IEEE P802.15
Wireless Personal Area Networks

Project	IEEE P802.15 Working Group for Wireless Personal Area Networks (WPANs)	
Title	Proposed Text on $\pi/2$ BPSK and (G) MSK description	
Date Submitted	September, 9 th , 2008	
Source	[R. Funada]	Voice: [[+81-46-847-5055] Fax: [[+81-46-847-5440] E-mail: [funada@nict.go.jp]
Re:	802.15.3c Teleconference Meeting	
Abstract	IEEE 802.15 Task Group TG3c Comment Resolution	
Purpose	Resolutions for the $\pi/2$ BPSK and (G) MSK description	
Notice	This document has been prepared to assist the IEEE P802.15. It is offered as a basis for discussion and is not binding on the contributing individual(s) or organization(s). The material in this document is subject to change in form and content after further study. The contributor(s) reserve(s) the right to add, amend or withdraw material contained herein.	
Release	The contributor acknowledges and accepts that this contribution becomes the property of IEEE and may be made publicly available by P802.15.

12.2.2.1.1 $\pi/2$ BPSK, Pre-coded (G)MSK

Figure 189—Constellation maps for modulation schemes: (a) $\pi/2$ BPSK, (b) pre-coded (G)MSK, (c) $\pi/2$ QPSK

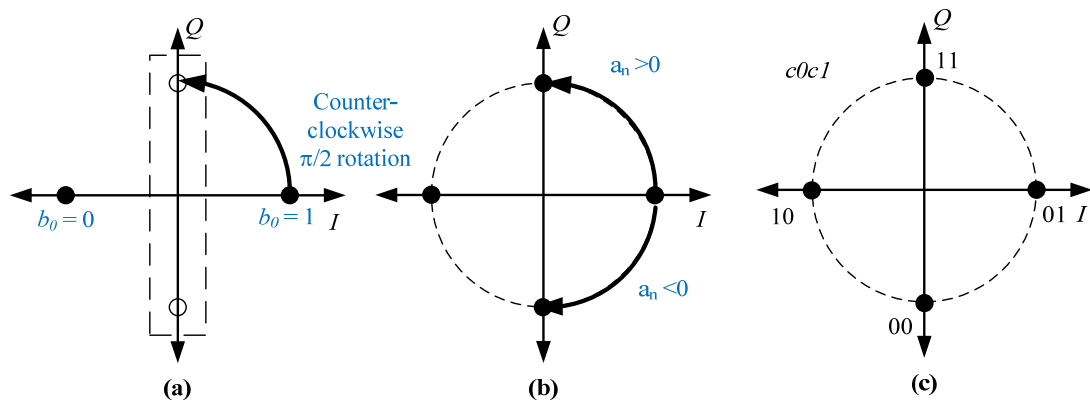
The $\pi/2$ -shift BPSK ($\pi/2$ BPSK) modulation uses two phases separated by π radian, as illustrated in Figure 189(a). The $\pi/2$ phase shift is made counter-clockwise to eliminate the π phase shift. Figure 189(a) shows signal constellation of $\pi/2$ BPSK signals. As shown in Figure 189(a), the black dot indicates the initial constellation point on the horizontal axis. In the next bit timing, the black dot is rotated to either hollow dot on the vertical axis. If b_0, b_1, \dots, b_{n-1} are unipolar bits to be transmitted, they are mapped to bipolar bits d_0, d_1, \dots, d_{n-1} , where bit “0” is mapped on “-1” and bit “1” on “+1”. The bipolar bit stream is then mapped onto constellation points z_n as

Pre-coded MSK are continuous phase modulation schemes by applying differential pre-coding before the MSK modulation. Note that the MSK constellation mapping is approximately equivalent to the $\pi/2$ -BPSK constellation as shown in Figure 189(b). The differential pre-coding is defined by

where, z_{-1} is $-j$. This encoding means the odd bits are mapped onto the real axis and the even bits are mapped onto the imaginary axis, as shown in Figure 189(b). Hence it is equivalent to the $\pi/2$ -BPSK constellation as shown in Figure 189(a) (Note that the normalization factor is 1). The maximum phase shift of MSK is equal to $\pi/2$ radian. The maximum phase shift of GMSK is equal to or less than $\pi/2$ radian due to Gaussian filtering. Note that filtered waveform of each modulation shall satisfy Transmit PSD mask as in 12.2.7.4.
